**CITY OF LEWISTON
PLANNING BOARD MEETING**
Monday, March 11, 2013 – 5:30 P.M.
Third Floor Conference Room
Lewiston City Building
27 Pine Street, Lewiston

TO: Planning Board
FROM: David Hediger, City Planner
DATE: March 7, 2013
RE: March 11, 2013 Planning Board Agenda Item IV(a)

An application submitted by Terradyn Consultants, LLC on behalf of Thompson Rolec Enterprises, LLC for the construction of a new 20,000 s.f. equipment repair building and outside equipment storage area at 14 Rousseau Way.

Subject: Comment Response – Thompson Rolec Equipment – City Review

THOMPSON ROLEC EQUIPMENT
SITE PLAN
 THOMPSON ROLEC ENTERPRISES, LLC
 70 BOX 1911
 LEWISTON, ME 04201
 SHEET 1 OF 7
 DATE 12/24
 SCALE 1/8"=1'-0"

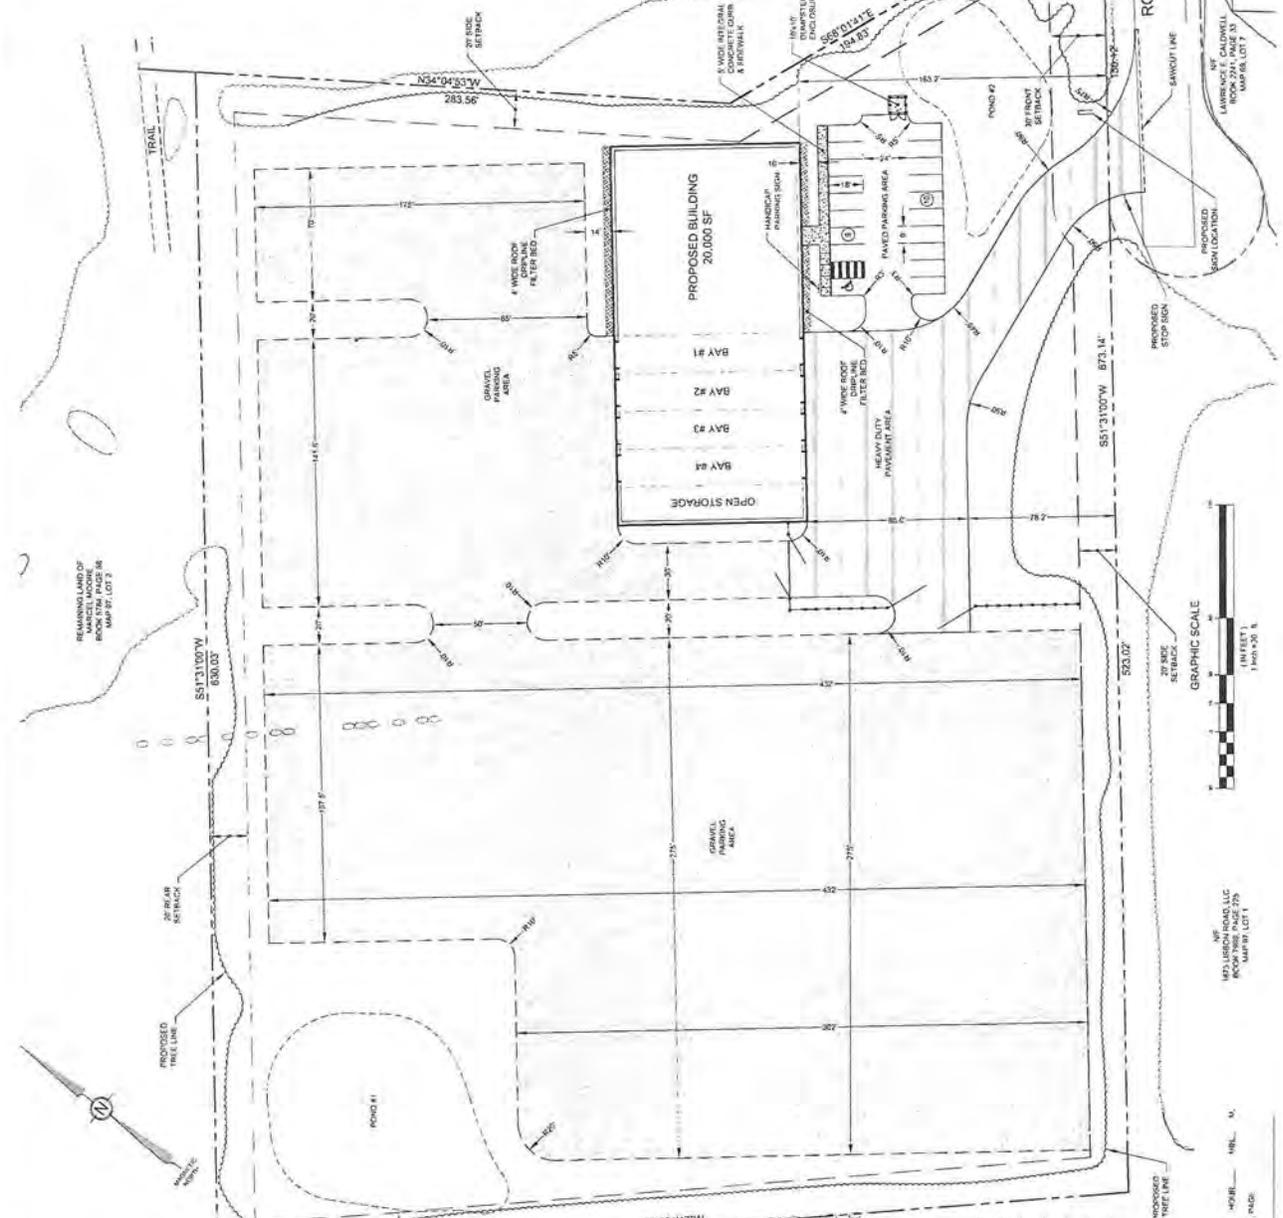
- The applicant is requesting a side yard modification along the western side property line by Rousseau Way (see sheet 1 and page four of applicants cover letter). The applicant acquired land from the self-storage facility at 7 North Lisbon Road along Rousseau Way to assemble the requisite frontage needed for 14 Rousseau to be a developable lot. In doing so, a portion of the paved access for the self-storage facility is now on the applicant's lot and creates a violation of the 10' side yard requirement in the HB. The applicant is requesting a modification pursuant to Article IX, Section 11 to allow for the paved area to remain within the required yard. Maintaining the paved area will continue to provide sufficient access around the self-storage site. With a modification allowed, the applicant proposes to grant an easement to the self-storage facility so that they may continue to use and maintain that portion of their parking lot now located on the applicant's lot. Should the modification not be granted, both the applicant and the self-storage facility will need to remove pavement from their side yards. Should the Board grant the requested modification, staff recommends as a condition of approval to be noted on Sheet 1 that no certificates of occupancy or use of the site for storage of equipment occur until an access easement is recorded between the applicant's property at 14 Rousseau Way and the self-storage facility at 7 North Lisbon Road. Said easement must reference a specific site plan showing the area of the yard modification, a standard boundary survey, and the Planning Board's approval of granting a yard modification in accordance with Article IX, Section 3(11) of the Zoning and Land Use Code.

4. The conditional use permit is valid for a period of 24-months from the date of approval to be consistent with the 24-month expiration of development review approved projects. This should be noted on plan sheet 1 as well as the expiration of approval language contained in Article XIII, Section 11.

1. Sheet 1:
 - a. Note 8 should be revised to reflect use as equipment dealer and equipment garage. Parking calculations must be revised to correct use.
 - b. Expiration of approval language from Article XIII, Section 11 must be added.

Response: Note 8 has been revised as requested. Parking calculations were revised accordingly. The expiration of approval language is included in Note #9 on the Site Plan.

PROJECT DESCRIPTION	SHEET NO.	TOTAL SHEETS
THOMPSON ROLEC EQUIPMENT	7	7

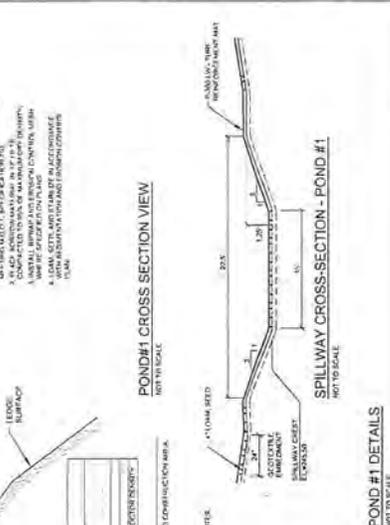
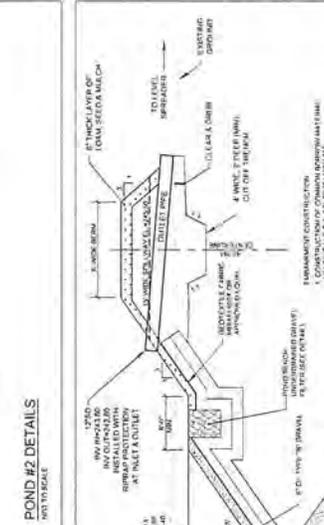
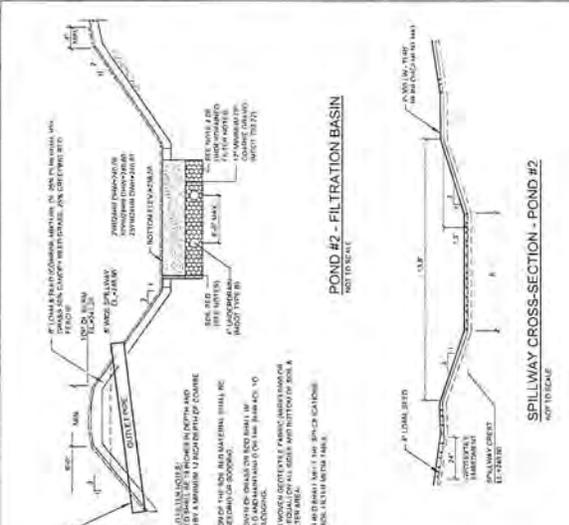
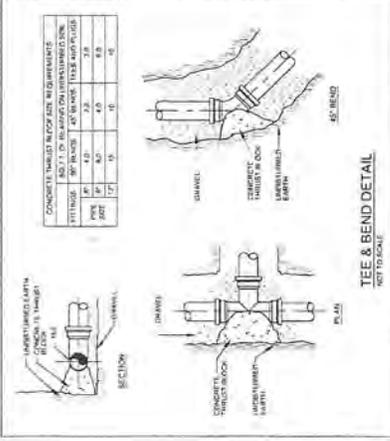
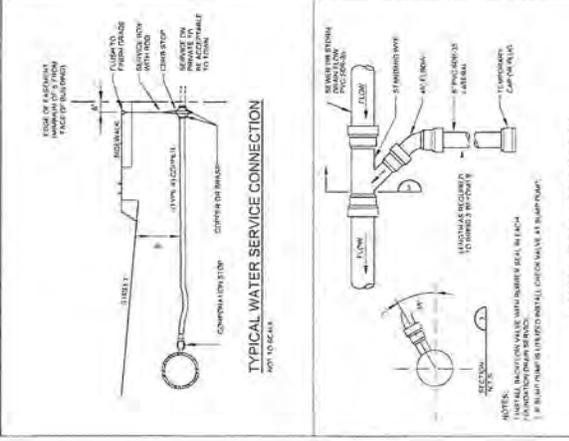
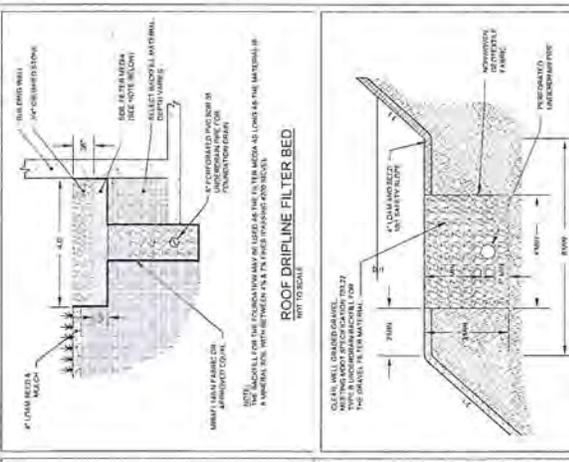
1. The *Typical Trench Section* detail shall be revised to include $\frac{3}{4}$ crushed stone to be used as backfill to 6" above the pipes.

2. The *Precast Sewer Manhole* detail shall be revised to include a note requiring new connections to existing structures to be cored and booted.

3. The details reference *Hot Bituminous Pavement Grade B & C*, these references are out of date and should be revised to include the Hot Mix Asphalt 19.0mm and 12.5mm mixes.

4. Note #4 of the *Pond #2 Filtration Basin* detail requires a nonwoven geotextile but specified Mirafi 600x which is a woven geotextile, please revise to specify a nonwoven geotextile.

Response: The Typical Trench Section detail has been revised as requested. See Sheet 5 of plans.

Response: The detail has been revised as requested. See Sheet 6 of plans.

Response: The details have been revised as requested. See Sheet 6 of plans.

Response: The detail has been modified accordingly. Mirafi S600, or approved equal is now specified.
